Ref Royal Elm Park
TEC letter dated 19 March 2023, ref Lt.2302016.001.01

ROYAL ELM PARK, READING – 160199/HYB

Monitoring Boreholes Location Plan

SK006 P01

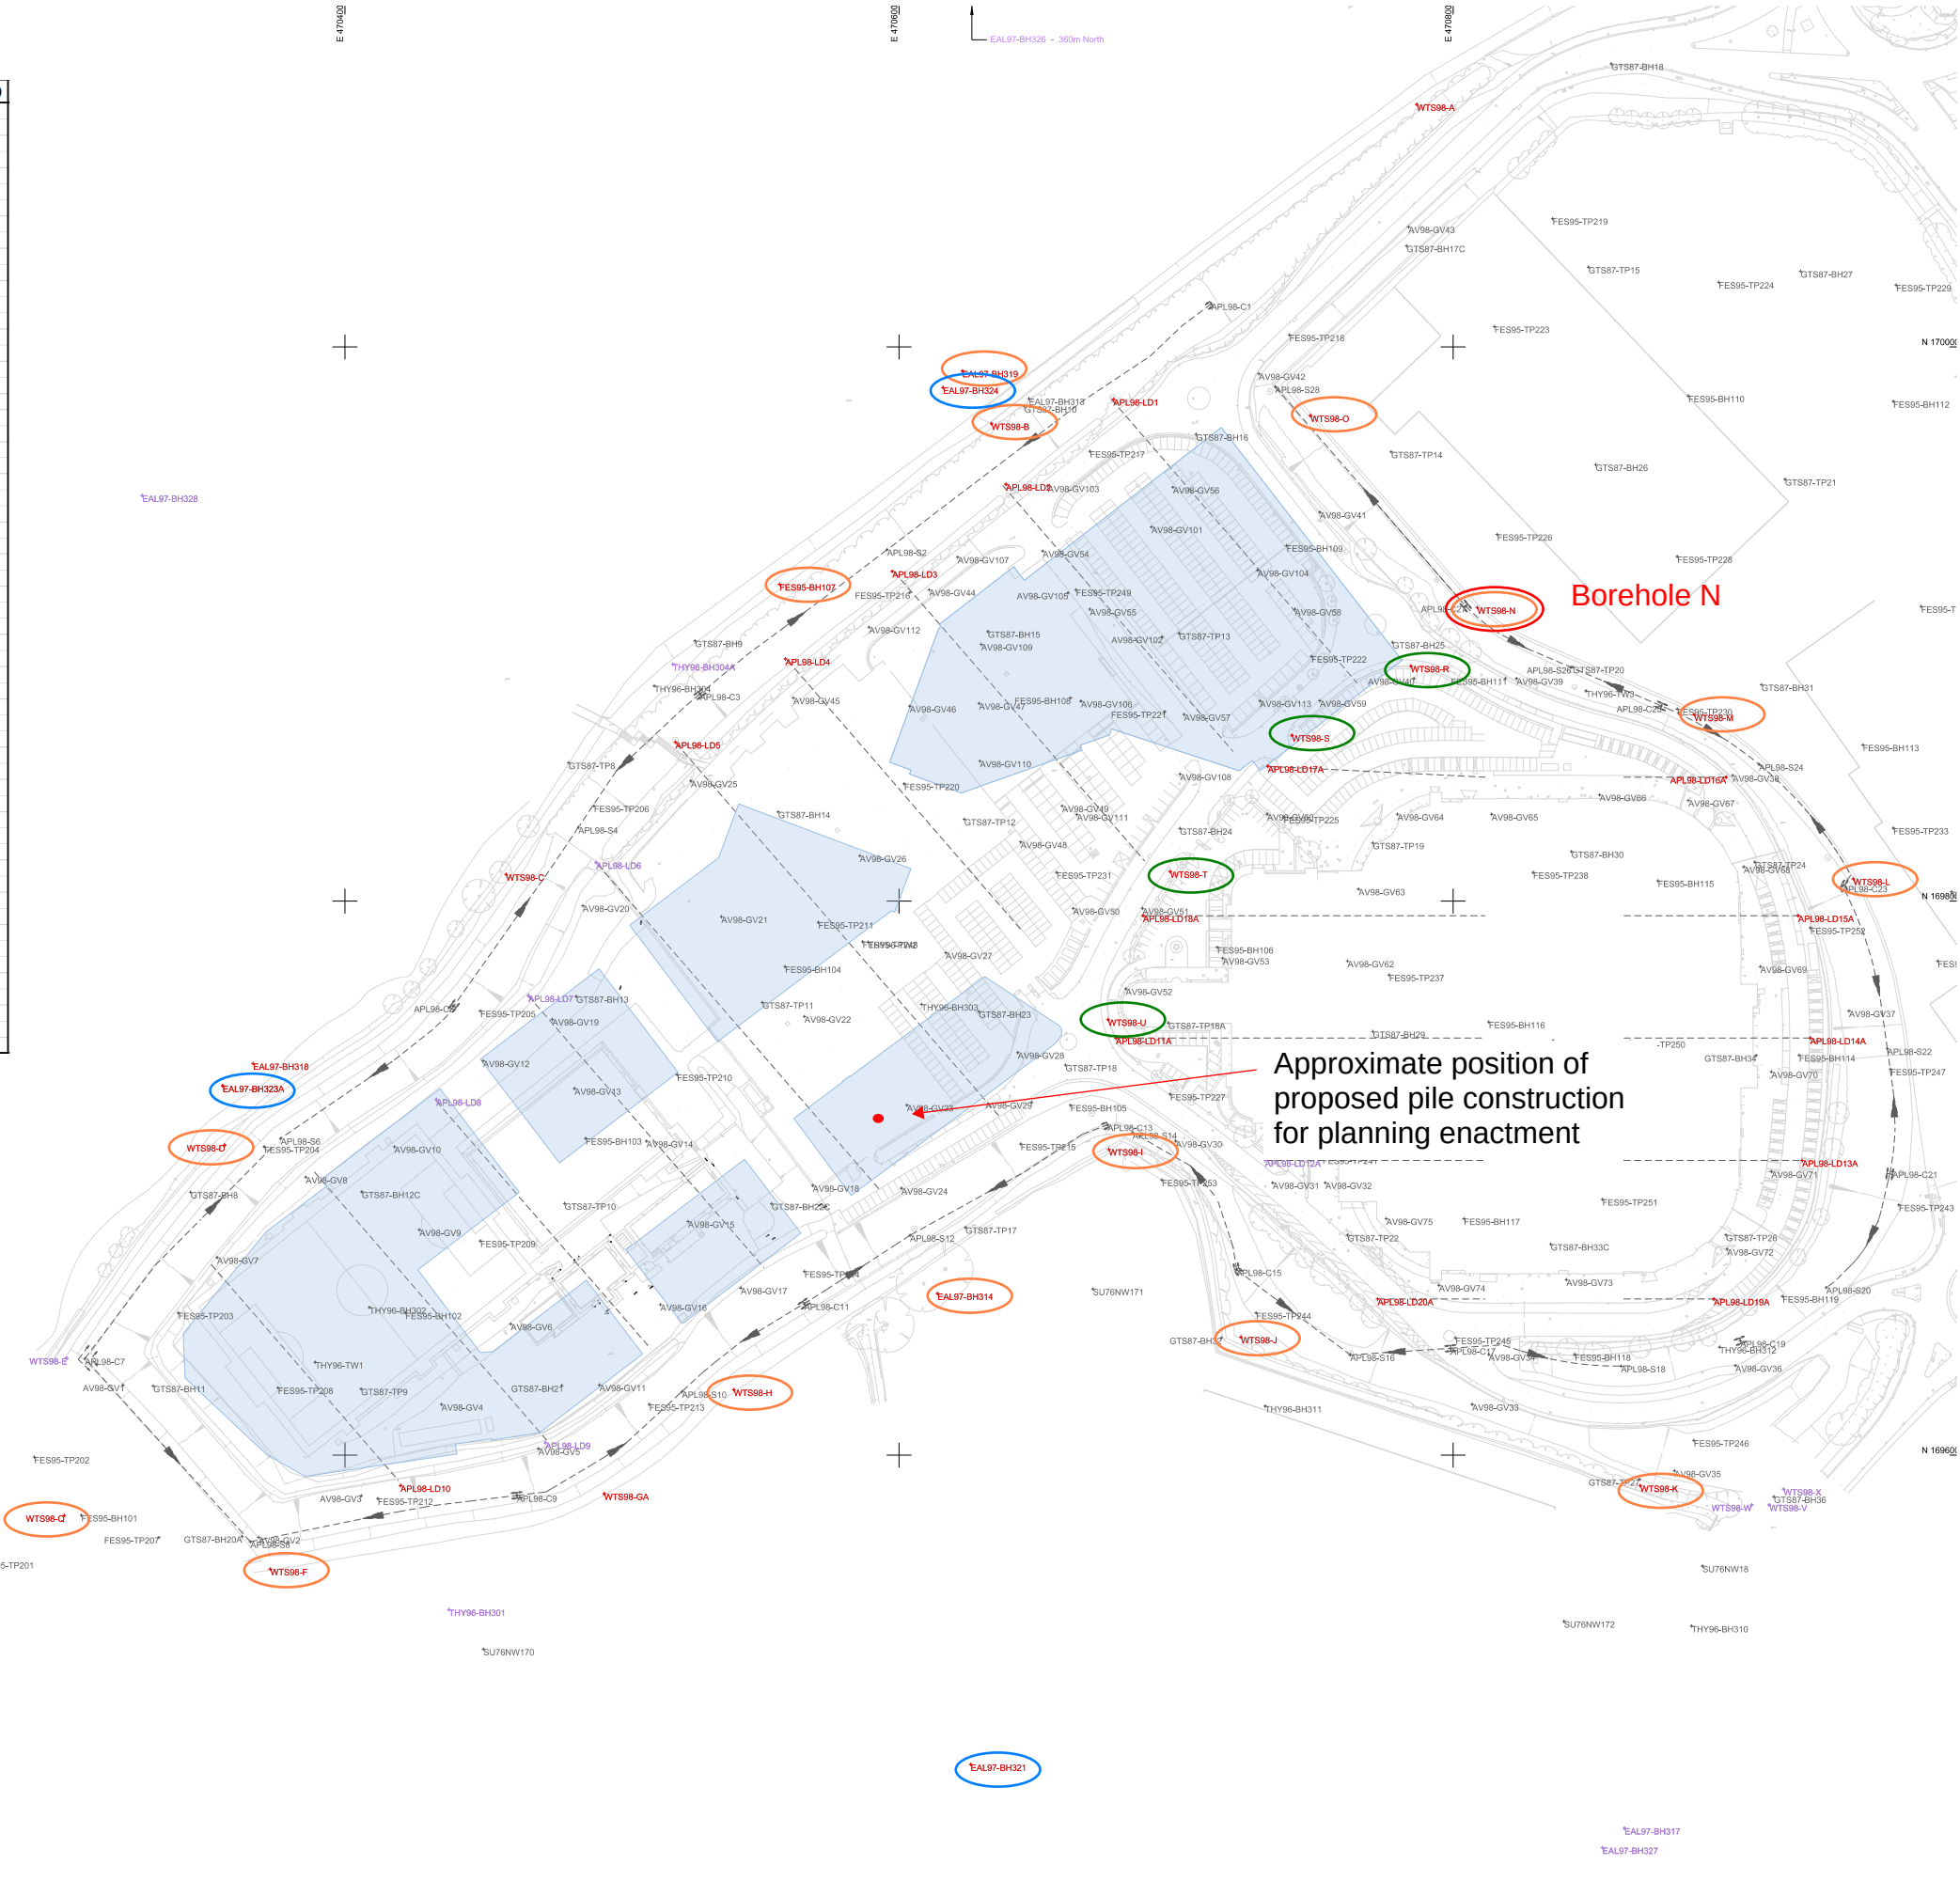
Ammoniacal nitrogen is reported to be at highest concentrations within the lower leachate wells and is reported to decrease in concentration within samples collected from the River Terrace Gravels and underlying Chalk. The report further indicates that data from 2011 – 2015 shows long-term stability or improvement of groundwater. However, it is also noted that concentrations are reported to increase within BHN from 2014. The location of this borehole in relation to the proposed pile location is unknown. ← Comment 1

From a review of the Environmental Statement (reference E002 rev C, dated December 2017), as summarised above, it is considered that a current assessment of the nature and extent of contamination (including groundwater and ground gas covered in more detail below) is required in associated with Condition 3, to inform decision making regarding the partial or phased discharge of Planning Conditions 4, 7, 68, 70, 71, 72, 73, 74, 79 and 80 detailed within the Planning Performance Agreement (PPA) for the site, dated February 2023. This should include confirmation of any proposed 'zones' within the site in relation to the current development layout and a plan indicating the location of the proposed single pile in relation to the wider site and any defined zones. Comment 7

1. The location of borehole N is highlighted on the attached sketch SK 005 Monitoring Boreholes Location Plan.
2. The attached Ramboll report, dated 31 May 2023, provides detailed analysis of groundwater data from 2015 to March 2023.

With respect to groundwater monitoring, item (b), monitoring of boreholes with the River Terrace Gravels (RTG) zones and the London Clay and Chalk zones, identified on SK005, will be carried out monthly post construction of the pile or a period of 4 months. The RTG zone has historically recorded the highest ammoniacal nitrate concentrations and are nearest to the base of the land-raise. It is reasonable to assume that any spike in groundwater contamination will first be noticed in the RTG zone. These boreholes are positioned around the complete perimeter of the site and so will intercept contamination via the most prevalent groundwater flow direction. Monitoring will revert to the agreed schedule of monitoring in accordance with RFC's Landfill Licence after the first 4 months of monitoring.
